# DEVELOPMENT REVIEW BOARD REPORT

**Mountain View  
Shopping Center -  
Exterior Remodel  
22-DR-2023**

Request for approval of exterior building modifications to an existing shopping center, including the removal of the existing arcade and changes to roofing material and paint for a +/- 7.6-acre site.

1 OVERALL SITE PLAN  
1" = 40'-0"

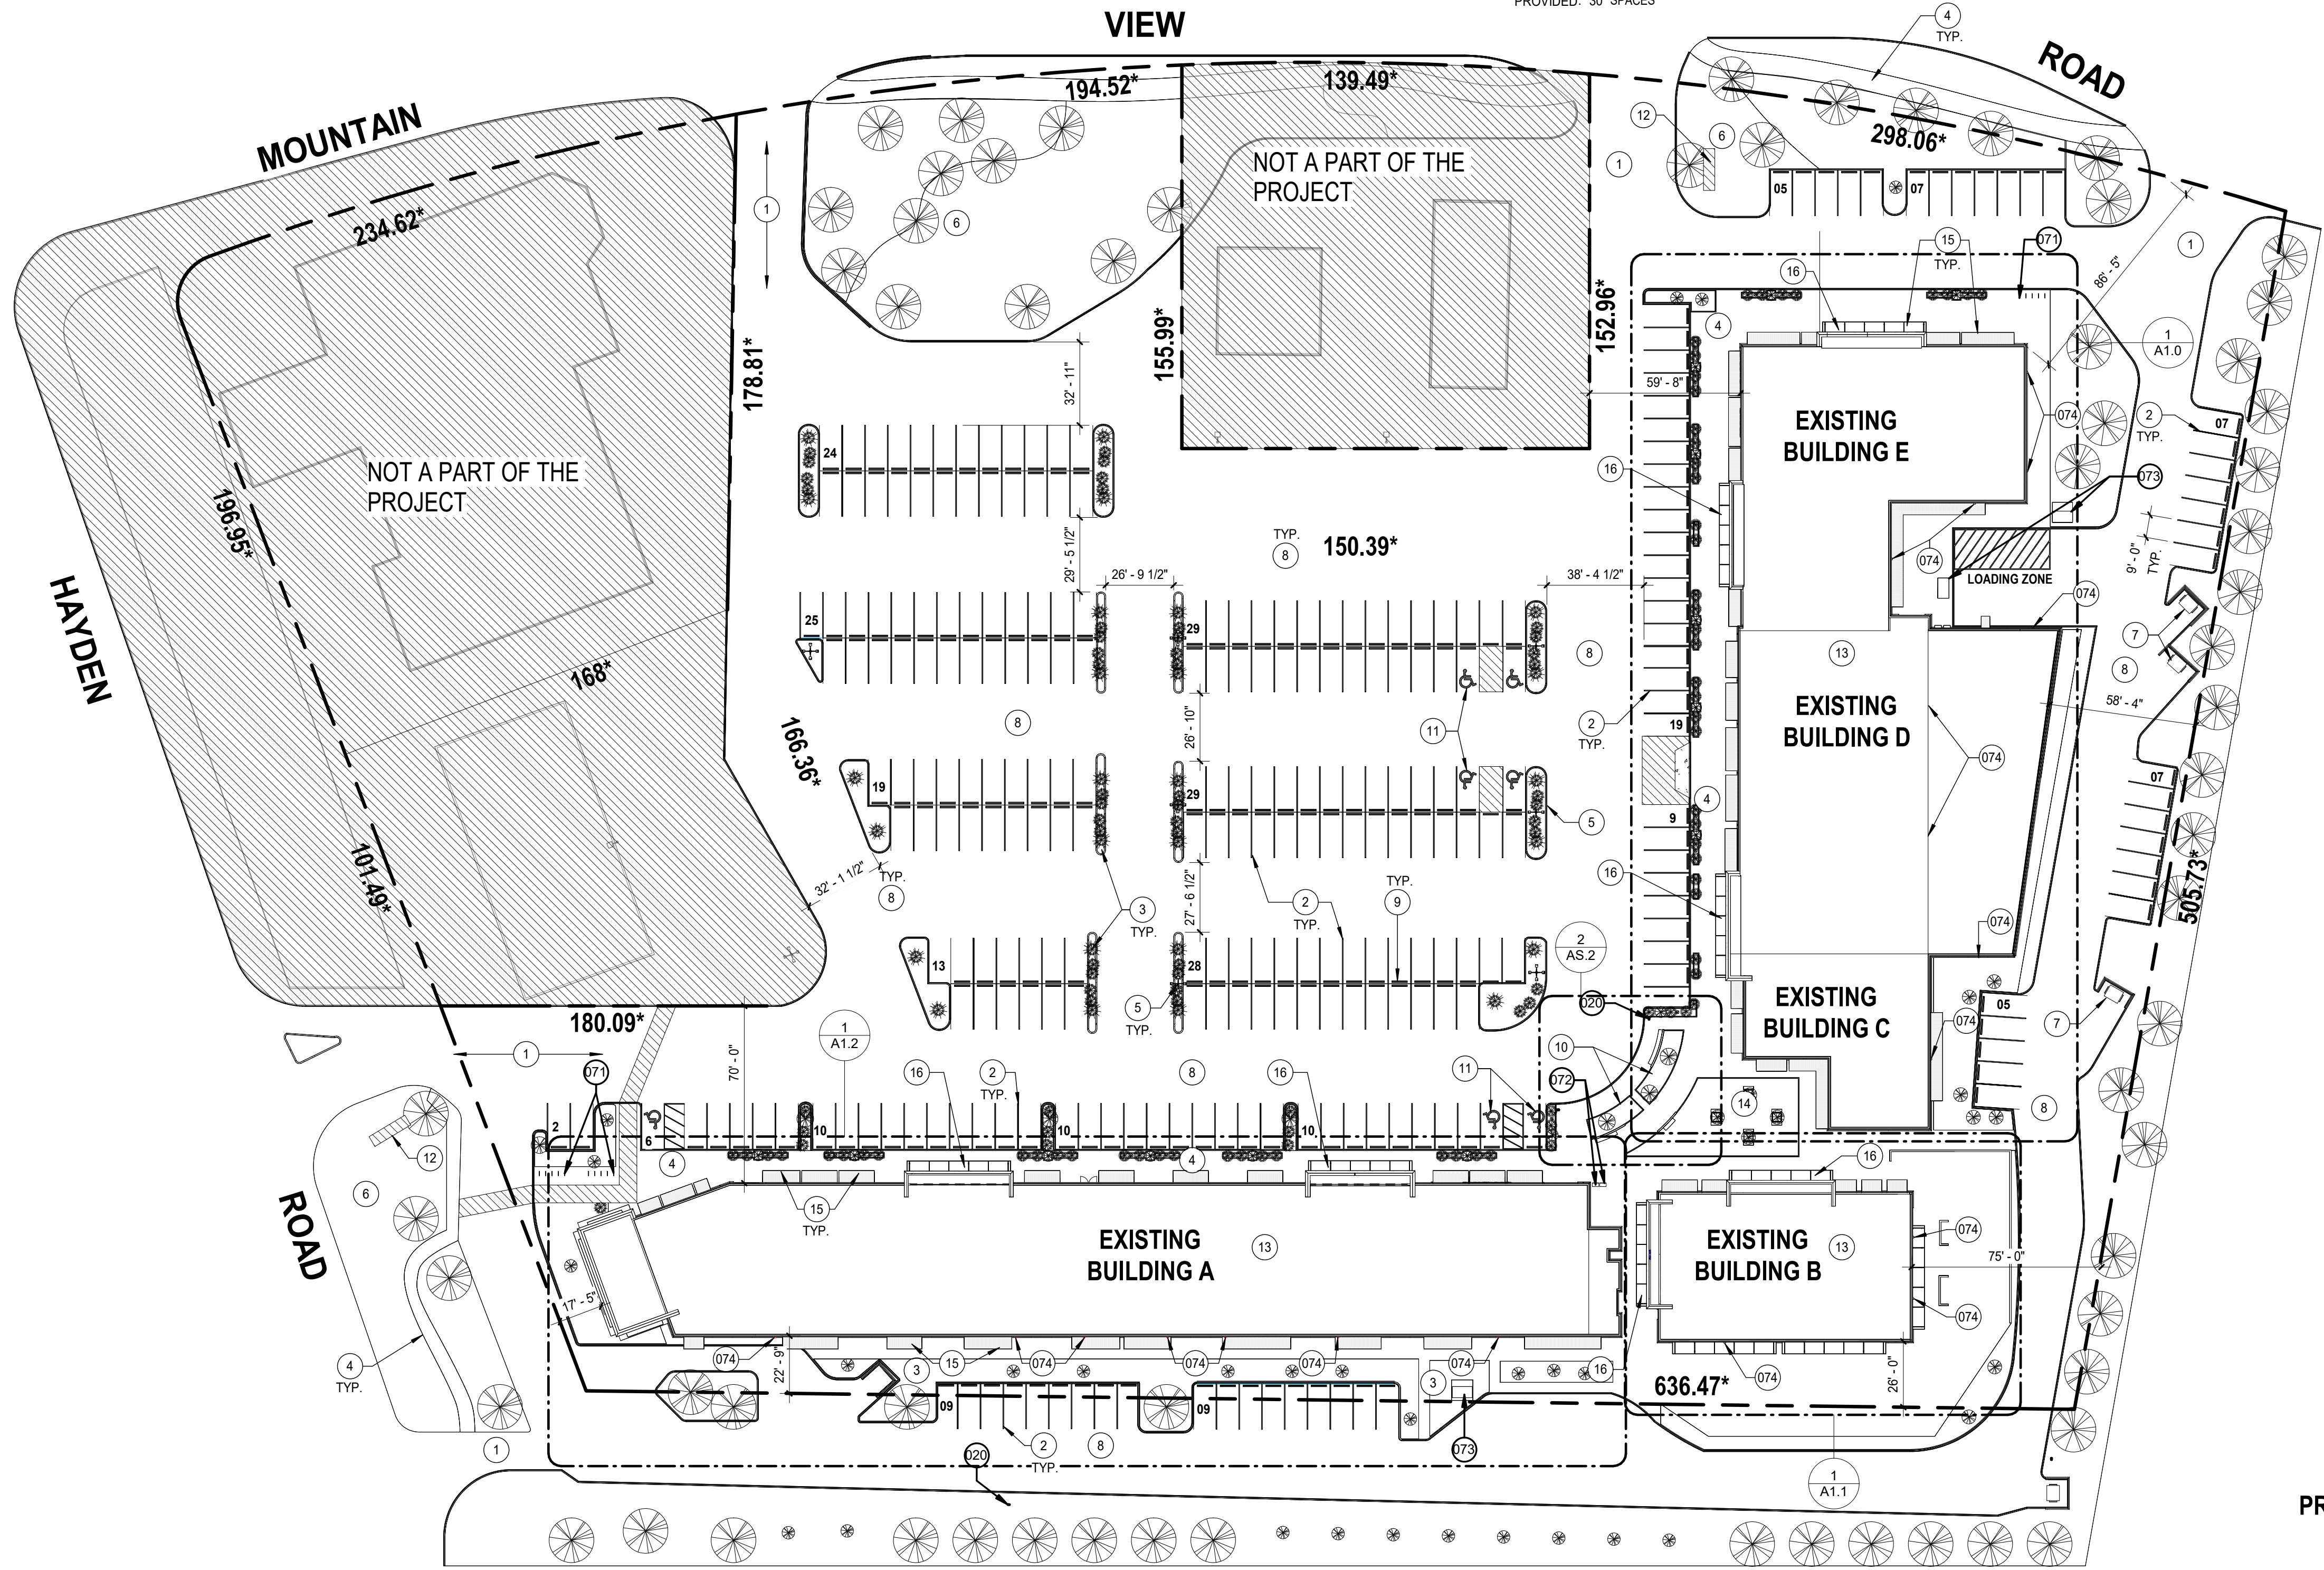
- b. The location and configuration of all site improvements shall be consistent with the site plan submitted by Stewart + Reindersma Architecture, PLLC, with a city staff date of 12/21/2023.
